Re: **Tronox LLC (TRX) Facility
Nevada Environmental Response Trust (Trust) Property
NDEP Facility ID #H-000539 (DEP # 22-026)**
*Nevada Division of Environmental Protection (NDEP) Response to Groundwater
Residence Time Distributions within the Nevada Environmental Response Trust (NERT)
Site, Henderson, Nevada; Remote Sensing of Evapotranspiration at the Nevada
Environmental Response Trust Site and Nearby Properties*

Dated: March 23, 2023

Remote Sensing of Evapotranspiration at the Nevada Environmental Response Trust Site and Nearby Properties, dated 03/23/2023

Groundwater Residence Time Distributions within the Nevada Environmental Response Trust (NERT) Site, Henderson, Nevada, dated 03/23/2023

Figure 1: Location of overlapping ETg and the Las Vegas Wash Areas

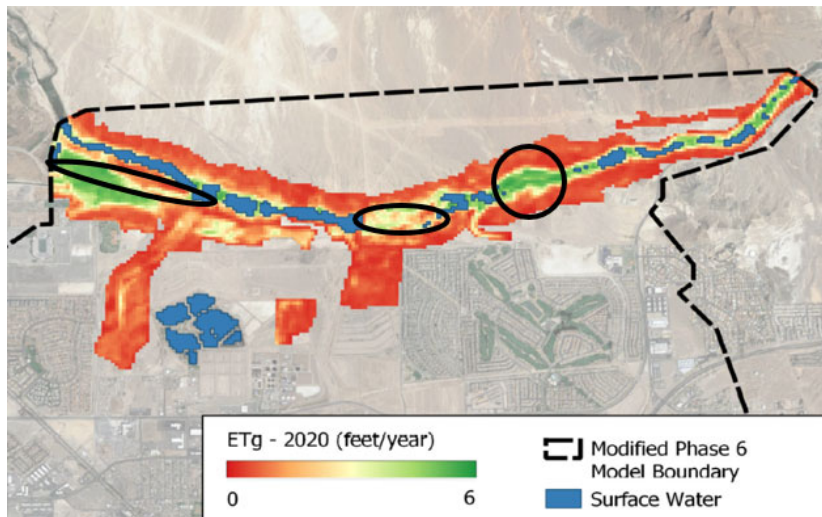
2. In some areas, the extent of open water in Las Vegas Wash has not been correctly identified. For example, in Figure 1 below, there are black ovals around areas where portions of the Wash open water have been misidentified as areas of evapotranspiration (ETg). This causes the total volume of ETg to be overestimated and the total amount of evaporation to be underestimated. This extent of the Wash will be corrected in the Phase 7 model. As a result, the total volume of ETg will be lower in the Phase 7 model than estimated in the report. Please review the open water for all images used in this report and correct it if it is needed.

Figure 2: Comparison of the DRI estimates with the Conceptual and simulated ETg estimates from the Phase 6 and the Phase 7 Models

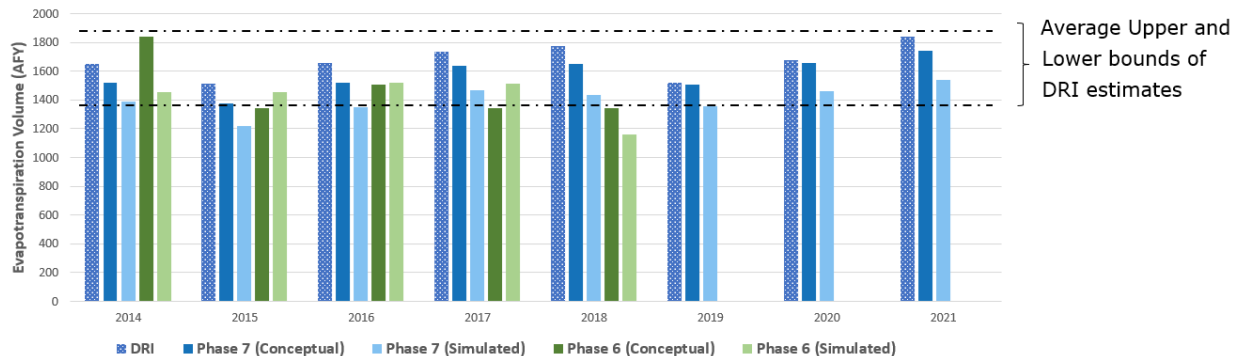
3. The report might benefit from a more in-depth discussion of the comparison of the results with the Phase 6 model and the potential implications of the estimates for the Phase 7 modeling work (Figure 2).

Figure 3: Comparison of the DRI estimates with the Conceptual and simulated ETg estimates from the Phase 6 and the Phase 7 Models

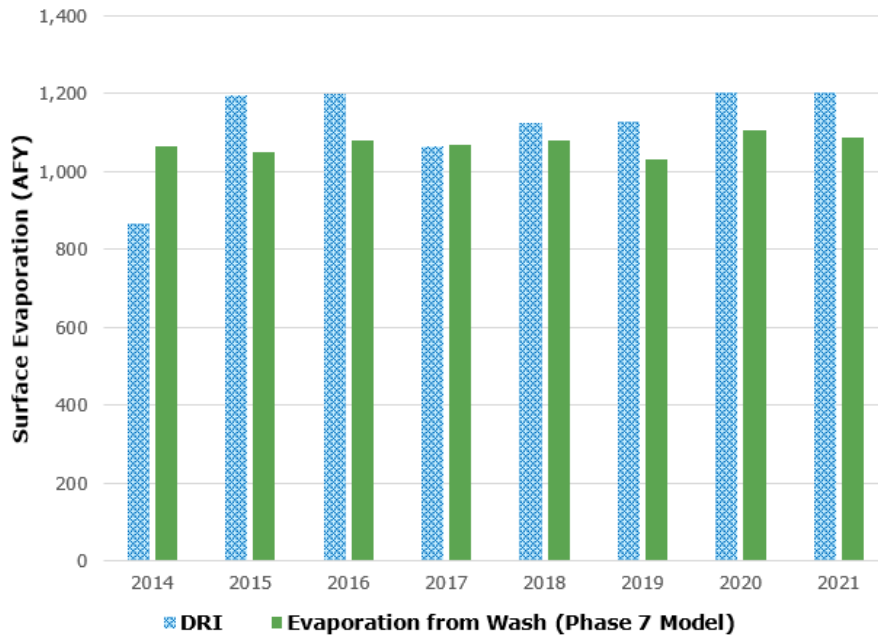
- The report should explain that some simplification of the results may be necessary when incorporating them into a groundwater model. To limit the complexity of the groundwater model, Ramboll (NERT's Consultant) will use spatially averaged ET parameters for each quarter in the model (parameters will vary with time but not in space). Similarly, for the surface evaporation rates, Ramboll will use the average rates for each quarter in the stream package (SFR) and for the conceptual estimate of recharge from the Bird Viewing Pond (Figure 3). It should be noted that the surface area of the Las Vegas Wash will remain constant throughout the Phase 7 model simulation.

Figure 4: Location of Selected Wells for the Study

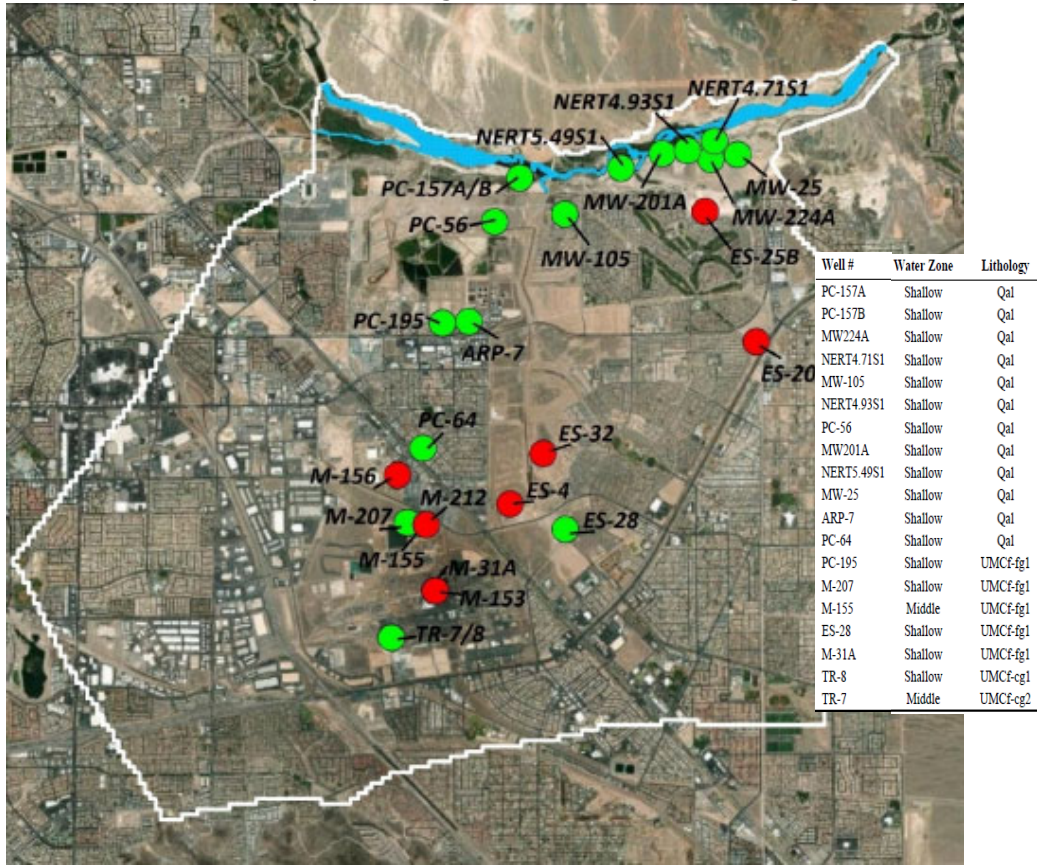
1. The report is comprehensive but would benefit from a clear summary of age-dating results for each well that was sampled using methods that do not rely on comparison to the Phase 6 groundwater model. As described below, there are significant limitations to the approach of attempting to interpret age tracer results using the Phase 6 groundwater model. Wells sampled for age tracers are shown in Figure 4.

Figure 5: Location of Wastewater Discharge Ponds (1945-1990)

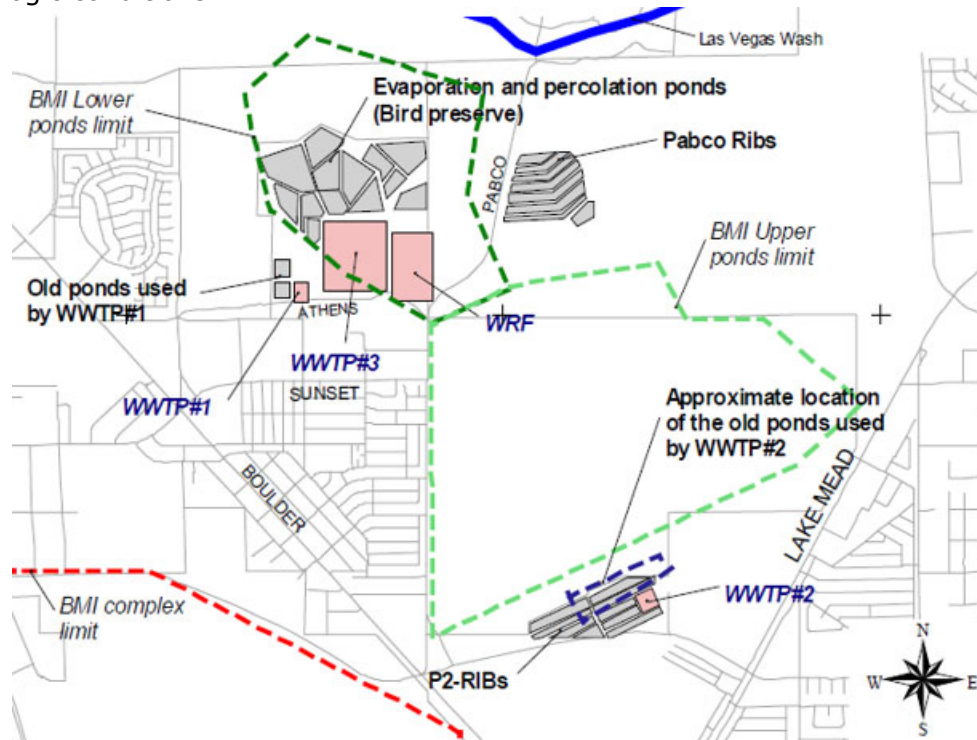
2. This study extensively uses the approach of attempting to replicate groundwater ages estimated from age tracers measured in shallow monitoring wells with ages estimated using the Phase 6 groundwater model. For the study area, this approach has significant limitations because the historical hydrologic conditions were dramatically different than the current hydrologic conditions that the Phase 6 model was designed to simulate. Most significantly, the widespread use of surface disposal of wastewater into ponds and ditches during the period of the 1940s to 1970s resulted in recharge into shallow groundwater of young water (<70 years old) essentially throughout the entire study area (Figure 5). Of course, it was this historical wastewater disposal that also largely caused the widespread contamination of groundwater. The current plumes of contamination are direct evidence of the extent and persistence of the historical recharge of young water. This historical recharge is not represented by the Phase 6 groundwater model because the model was designed to simulate current conditions (2004-present) after surface disposal of wastewater had largely ceased. As a result, the groundwater ages in shallow wells predicted by the Phase 6 model are generally much

longer than those estimated from age tracers. The report does not fully acknowledge the limitations of the approach of comparing age tracer and model results, and it incorrectly implies that the discrepancy in groundwater ages between age tracers and the model indicates flaws in the groundwater model. On the contrary, the discrepancy points out the limitations of the approach of trying to match a model that only simulates current hydrologic conditions.
